From: Wortman, Eric
Sent: Monday, January 8, 2018 8:02 AM
To: Wortman, Eric
Subject: Notice of Public Comment Period – Proposed Permits to Construct on the Uintah and Ouray Indian Reservation
Attachments: Bulletin Board Notice - Anadarko SMNSR CD Transfer Permits - Multiple Fa....pdf

Re: Anadarko Uintah Midstream, LLC, Proposed Synthetic Minor New Source Review Permits for Multiple Facilities

SUBJECT: Uintah and Ouray Indian Reservation, Archie Bench Compressor Station;
Anadarko Uintah Midstream, LLC., Environmental Justice

**RE: Synthetic Minor NSR Permit Application under Part 49
Archie Bench Compressor Station**

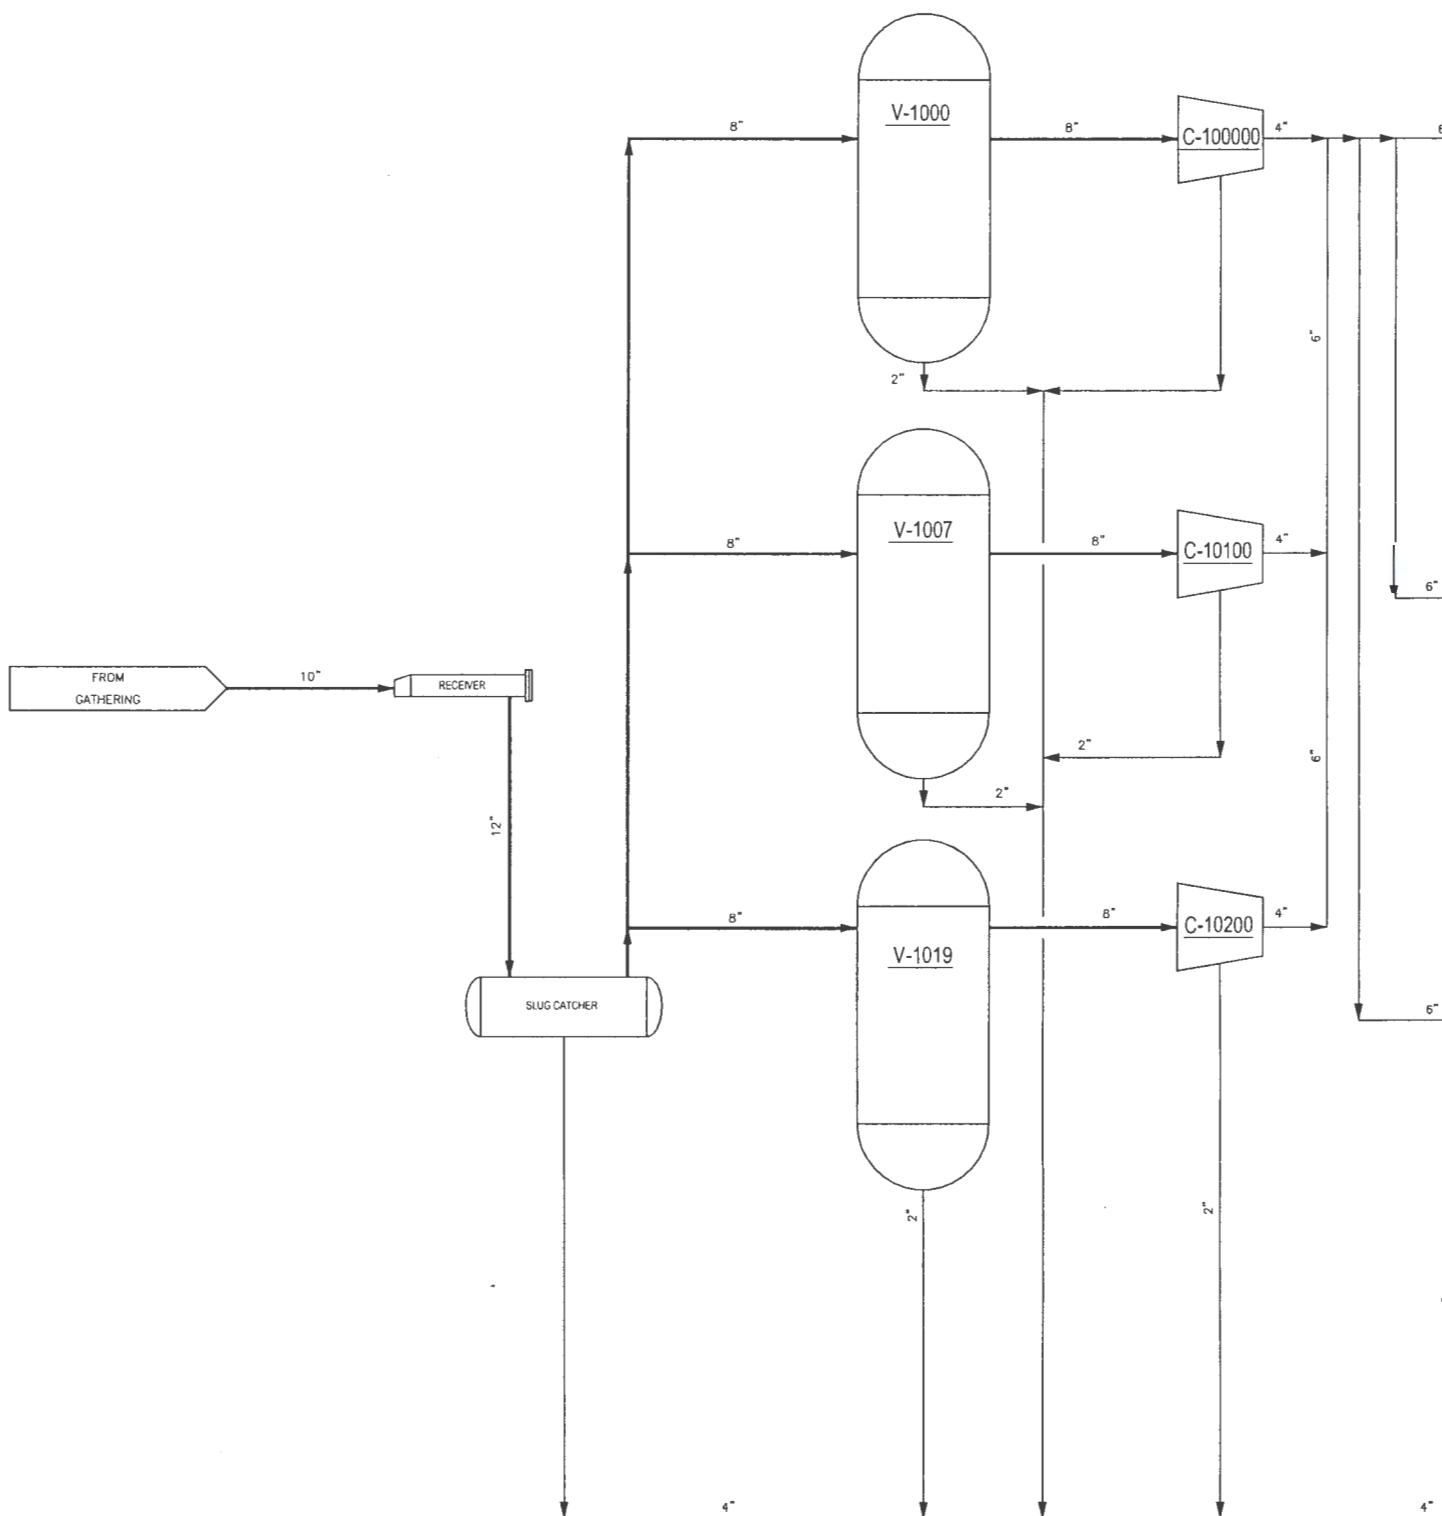
- Please provide the capacity of the three condensate/produced water tanks. The tank size is not in the application. Additionally, the process description states that condensate is sent to the blowcase system and injected into the discharge line, but also states it is stored in the produced water tanks. Please clarify this discrepancy. – Archie bench has (1) 400bbl and (2) 300bbl condensate tanks. Similar to the Bitter Creek station, Archie Bench station has both condensate tanks and a blowcase system. Condensate can be stored or sent through the blowcase.

- The application indicates there are three H2S air strippers at the facility. Please send me a sentence or two about how these units fit in to the facility operations that I can include in the process description. Please verify that there are no emissions associated with these units (nothing in PTE tables). Archie Bench compressor station has three gas to liquid H2S scrubbers. Each scrubber consists of a vertical vessel where gas is introduced to a H2S scavenger liquid that removes H2S from the gas stream prior to it being sent to the a gas plant. There is no PTE associated with these scrubbers.
